**USEPA Superfund  
Interim Action Record of Decision**

Source Area Operable Unit  
B.F. Goodrich Superfund Site  
San Bernardino County, CA  
EPA ID: CAN000905945

September 30, 2010

Figure 1 -Extracted from Anderson et al and illustrating the location of the Rialto-Colton Fault Zone as determined by Anderson et al (RCF) and Dutcher and Garrett (D-G H)

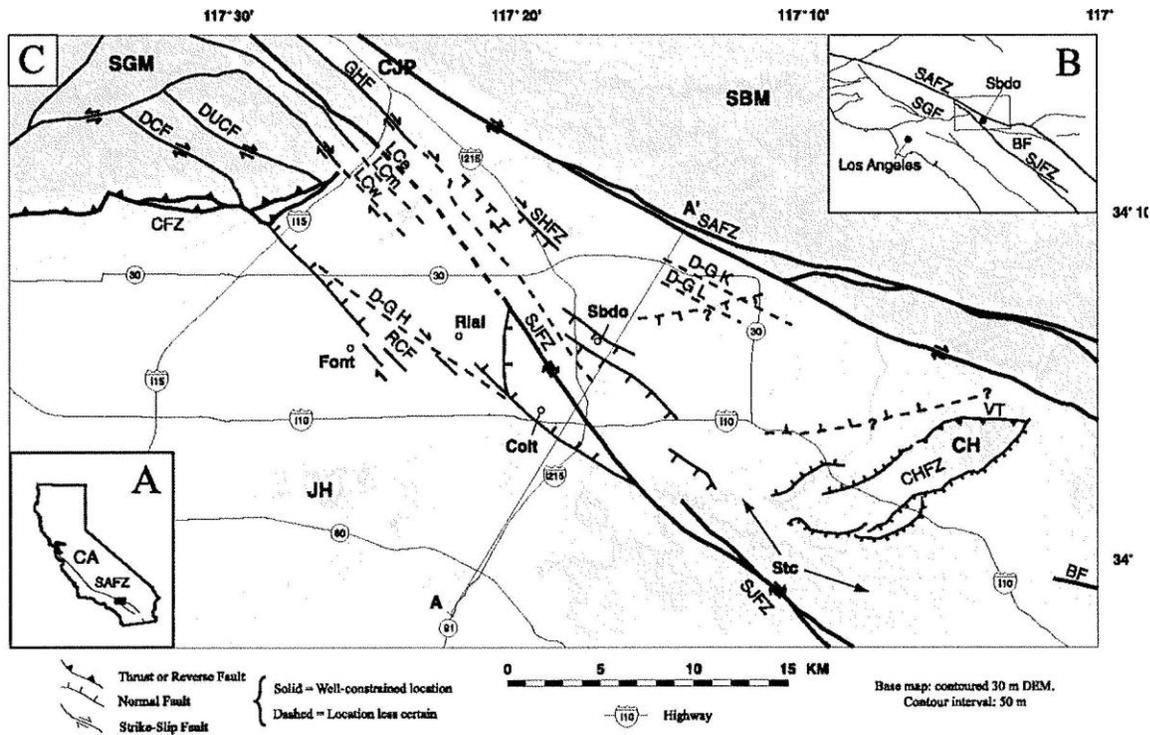
*Figure 1, below, is extracted from the Anderson paper and illustrates clearly the difference in location of the RCF Zone, as determined by the Gandhok and Anderson*

*work and the prior location of the fault, as depicted by Dutcher and Garrett<sup>3</sup>. A review of Plate 1 from Dutcher and Garrett actually shows that the Rialto-Colton Fault and Barrier H form a fault zone (in congruence with the findings of Gandhok et al), as opposed to a single continuous RC fault and shorter Barrier H, as depicted in the RI/FS. The basic difference between Anderson et al and Dutcher and Garrett is in the location of Barrier H and the structure of the Rialto Colton Fault (see further discussion below regarding the placement of Barrier H).*

*In addition to the misrepresentation of the Rialto-Colton Fault Zone (RCFZ) and Barrier H, the EPA modeling assumes that the northwestern section of the RCFZ is impervious, which is contrary to the fact that at least four hydrogeological maps of groundwater contours in the northern Chino Basin indicate flow through this section of the RCF Zone.*

**FIGURE 3 -Extracted from RI/FS Figure 1-4. Schematic streamlines added in red.**

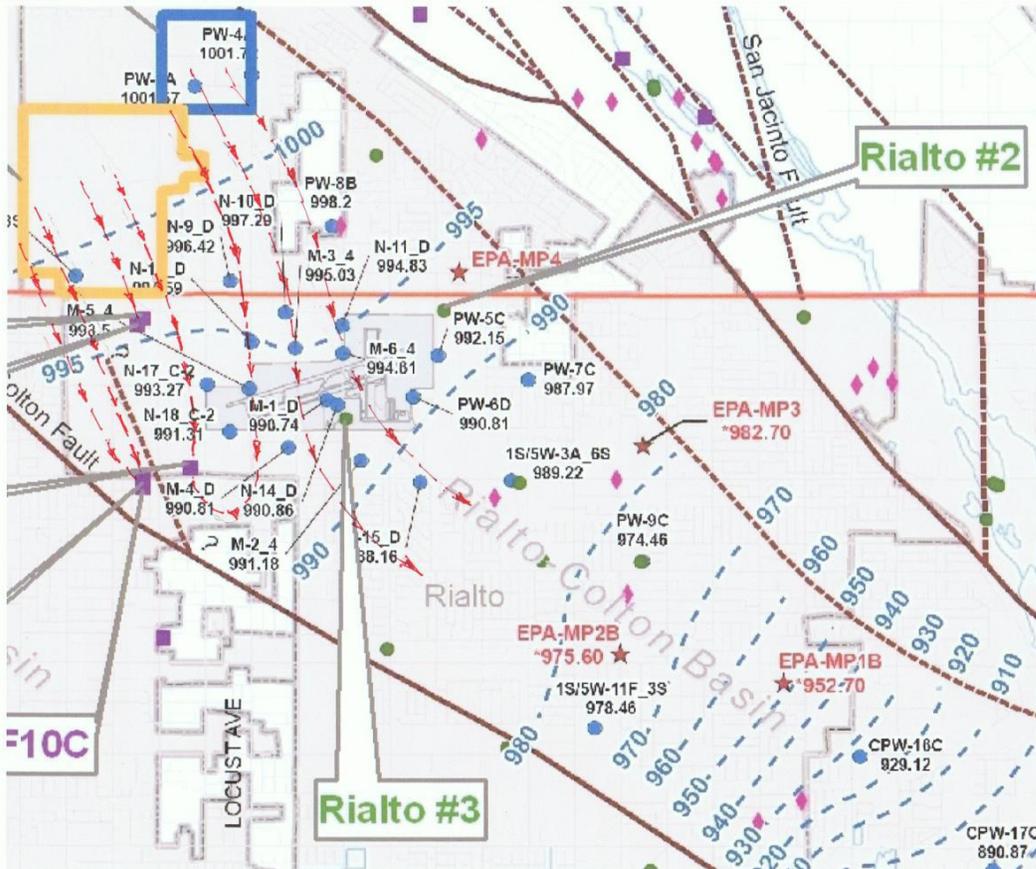
*The southwesterly flow of perchlorate is further indicated by the streamline directions implied by the groundwater elevation contours plotted in RI/FS Figure 1-4. Figure 3 below has been extracted from EPA Figure 1-4 to emphasize the groundwater contours not plotted between elevation 990 and 995. Streamlines inferred from these groundwater contours (plotted in red in Figure 3) clearly show transfer of perchlorate from the County site to FWC 13A/B, which is confirmed by the high fraction of synthetic perchlorate observed in well F13A during the recent preliminary chlorine and oxygen isotope studies. The plotted streamlines also indicate possible transfer of perchlorate from the Goodrich site to FWC well F49A. (Note that this figure also indicates the correct positions of FWC wells F10B/C, which are incorrectly placed in RI/FS Appendix figures, as discussed in more detail below.)*

*Note also in Figure 3 that the measured groundwater contours, and their associated streamlines that transport perchlorate to the FWC wells F13A/B, F10B/C and F49A (the purple squares on the map), agree in general form to those streamlines and contours in the same area shown in Figure 2.*

↳ **EPA Response:** Available water quality and water level data do not support the conclusion that there is southwesterly migration of perchlorate from the 160-Area Area to FWC’s wells in the western portion of the RCB. The streamlines depicted in Figure A-8 from the January 2010 RI/FS Report do not represent past or expected future conditions. They illustrate the potential movement of potentially contaminated groundwater in the extreme case that groundwater conditions observed in 2004 continued indefinitely. As stated in Section 3.3.1 of the RI/FS Report, the modeling results “should be interpreted carefully because the actual flow field varies from year to year and particular caution should be exercised in interpreting results when the selected flow field reflects extremely wet or dry years or other transient conditions.”

Furthermore, EPA has carefully reviewed the figures and data provided with or referenced in the comment and does not find any evidence to support a conclusion that perchlorate contamination from the B.F. Goodrich Site has impacted FWC’s wells. The streamlines added to EPA’s Figures A-8 and 1-4 (included as Figures 2 and 3 in the comment) inappropriately extrapolate from the extreme conditions shown in Figure A-8 or the snapshot shown in Figure 1-4. In addition, some of the streamlines do not accurately reflect and are not implied by the interpreted contours shown in the figures.

FIGURE 5 --Sections of RI/FS Figures 1-4 and A-8 in an overlay showing misplacement of Wells F10B/C and Barrier H. Figure also includes County and BROCO sites.

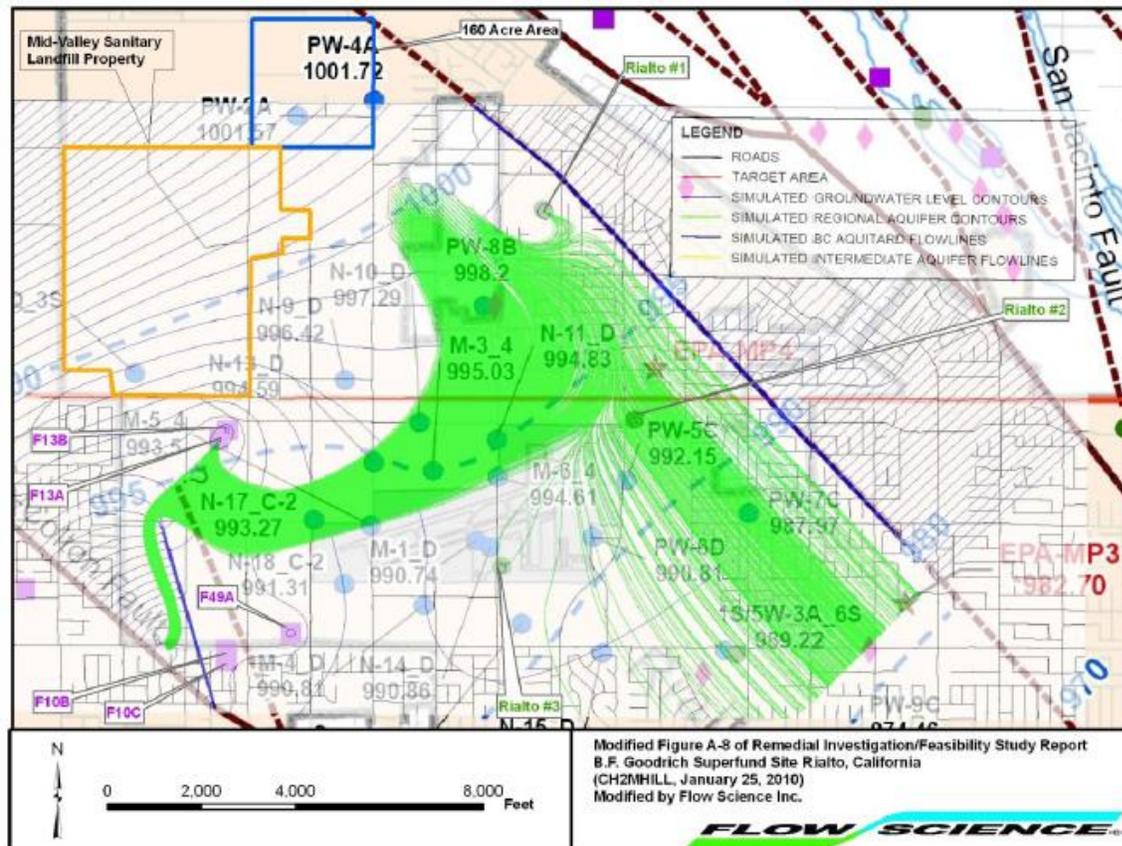
(i) The presumed position of Barrier H and the locations of FWC wells F10B and F10C are incorrectly positioned in the groundwater model. Figure 5 below is an overlay map created by Flow Science with a GIS system using Figures 1-4 and A-8 from the RI/FS. In the lower left hand corner of this figure two different locations for Barrier H can be seen. One shown as a dark blue solid line, as in Figure A-8, and the other a dotted light brown line, as in Figure 1-4. Wells F10B/C are not explicitly called out in Figure A-8, but their location is implied by the apex of the green particle paths. In Figure 1-4 these two wells are shown as overlapping light purple squares. Flow Science has checked the actual locations of Wells F10B/C and has marked these locations on Figure 5; they coincide with the locations shown in RI/FS Figure 1-4. The fact that Barrier H and the Wells F10B/C are apparently mislocated in the groundwater model will obviously change the computed groundwater contours and streamlines; how significant the change will be is difficult to assess without rerunning the model with the correct geometrical data.

Perhaps even more important than the mislocation of Barrier H is the presumption of its shape and impermeability. Given the uncertainty associated with both the location and structure of this “barrier” it would have been entirely appropriate to have performed model sensitivity analyses that omitted the barrier altogether.

↳EPA Response: If FWC Wells F-10B and F-10C, and Barrier H, are slightly misplaced in the groundwater model as is implied on Figure 5, EPA does not expect the change in location to

**FIGURE 6a -Groundwater elevation and perchlorate in sample well PW-2 Goodrich site.**  
 Source: Goodrich Corporation Progress Report for the Month of February 2008  
 160-Acre Parcel, Rialto, California  
 Geosyntec Project No. HA 0938

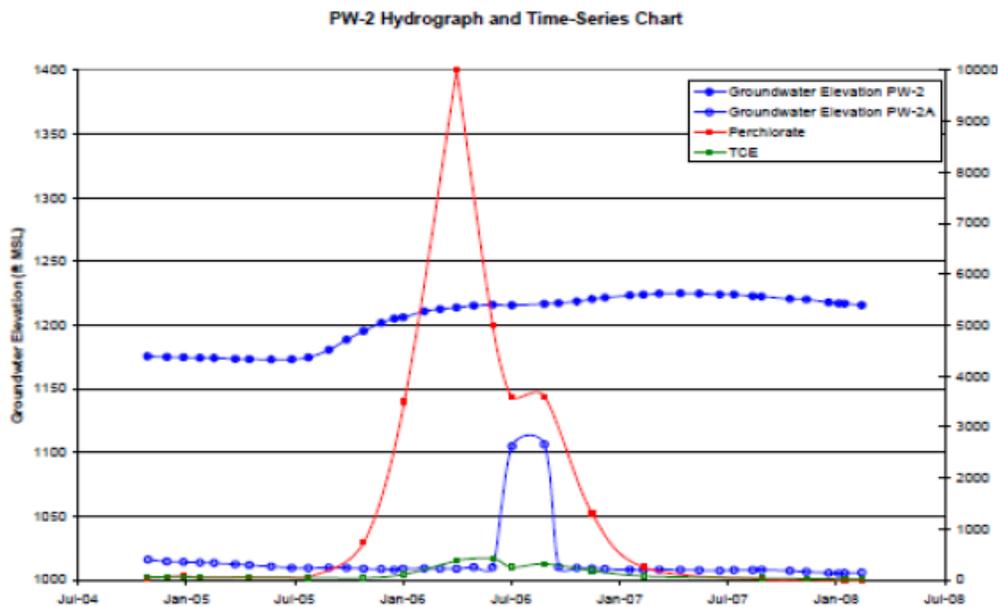
*However, as shown in the field data from the Goodrich site (Figures 6a and 6b) the water levels do not remain constant, and it is these changing water levels that give rise to the pulses of high concentration perchlorate in the groundwater. In the absence of any transfer from the Intermediate to the Regional Aquifer, where do the high concentrations in the Regional Aquifer come from?*

FIGURE 7 -Validation of the model versus City of Rialto wells.

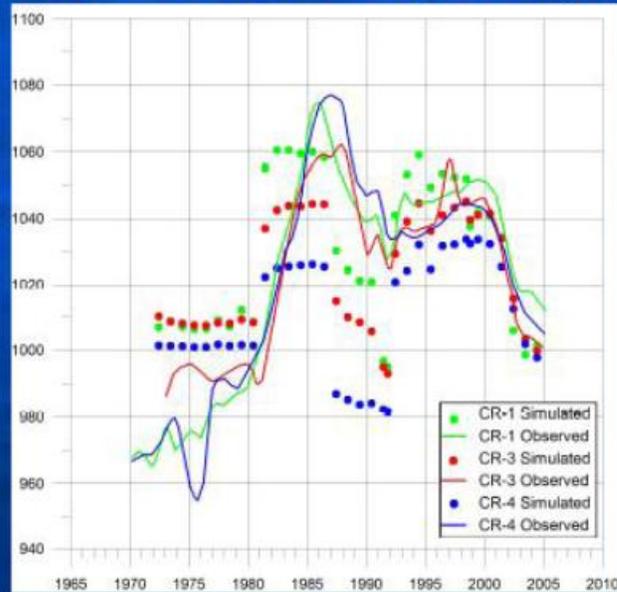
**Comment FWC-20.** *The attempted validation of the modeling as represented by RI/FS Figure A-6 (see Figure 7 below) shows a poor correlation with measured groundwater surface elevations in City of Rialto wells with elevation discrepancies of as much as 70 ft and also indicating groundwater slopes during the 1980's that are not present in the well data. In fact, the RI/FS concedes that the model even indicated flows out of the northwest boundary of the modeling region in the late 1980's and 1990's -basically saying that groundwater ran uphill! (See RI/FS Figure A-7a included here as Figure 8.)*

**FIGURE 8 -Extracted from RI/FS Figure A-7a showing negative boundary flows at the "upstream" northwest boundary to the model.**

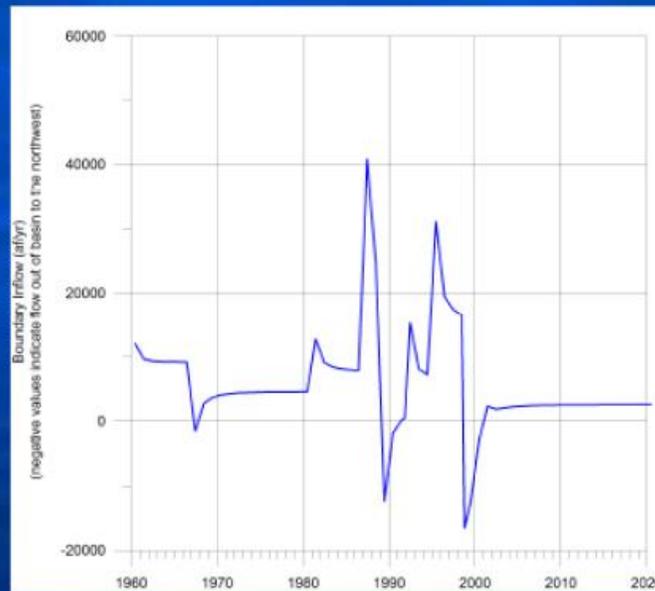
Boundary Inflow becomes negative in the late 1980s and 1990s. This implies an unlikely northwesterly flow direction near the upstream part of the model. This means that caution is needed when examining flow near this boundary
